Public Consultation Materials

RE: Block 27 Major Roads Municipal Class Environmental Assessment
Public Engagement and Consultation Plan

Block 27 Collector Roads Municipal Class Environmental Assessment

**Block 27 Collector Roads Municipal Class Environmental Assessment Study
TAC Meeting #2 Comment-Response Table**

Street 5 Alternative 5A

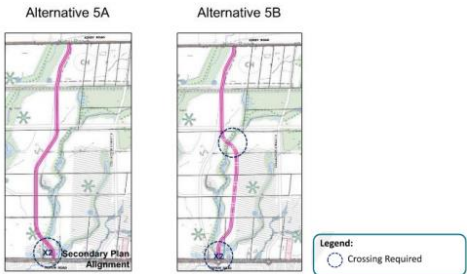
14.	<p>For Street 5 alternative 5A was given a higher score in the Surface Water and Drainage category as it notes it 'avoids flood plain crossings'. Consideration needs to be given however to the fact that alternative 5A requires a channel realignment which could be more detrimental to the natural system than a crossing over it. Please re-examine the scoring for Street 5 alternatives.</p>	<p>The comment that Alternative 5A avoids a flood plain crossing refers to the additional crossing on the northern segment of Street 5 that would be required with Alternative 5B (see figure below). Please note a channel realignment will be required for both Alternatives 5A and 5B at the Street 5 and Teston Road intersection.</p> 	Addressed.	-
-----	--	--	------------	---
